AD 94-11-04 Hub Arm Assembly

Effective Date: June 10, 1994

94-11-04 MITSUBISHI HEAVY INDUSTRIES, LTD.: Amendment 39-8920; Docket No. 94-CE-09-AD.

1. ROD
2. LEVER
3. CYLINDER ASSEMBLY
4. ROD (Reference dimension 3.39 inches \pm by 0.02 inches)
5. BELL CRANK
6. ROD
7. LEVER

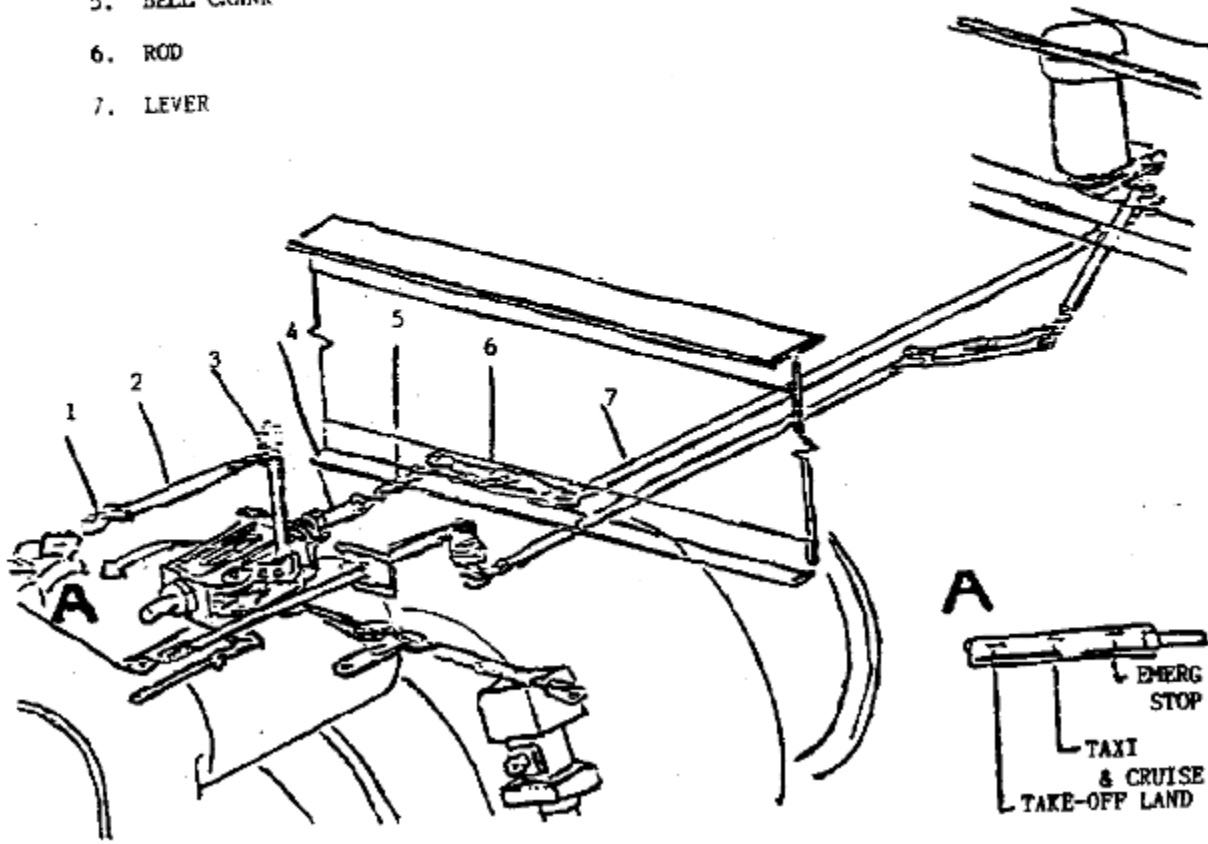
(b) Modify the airframe condition control linkage by adjusting Rod 1 and Levers 2 and 7 as specified in Figure 1 of this AD in accordance with Chapter 6, Section 9.2, of the applicable Mitsubishi MU-2 maintenance manual.
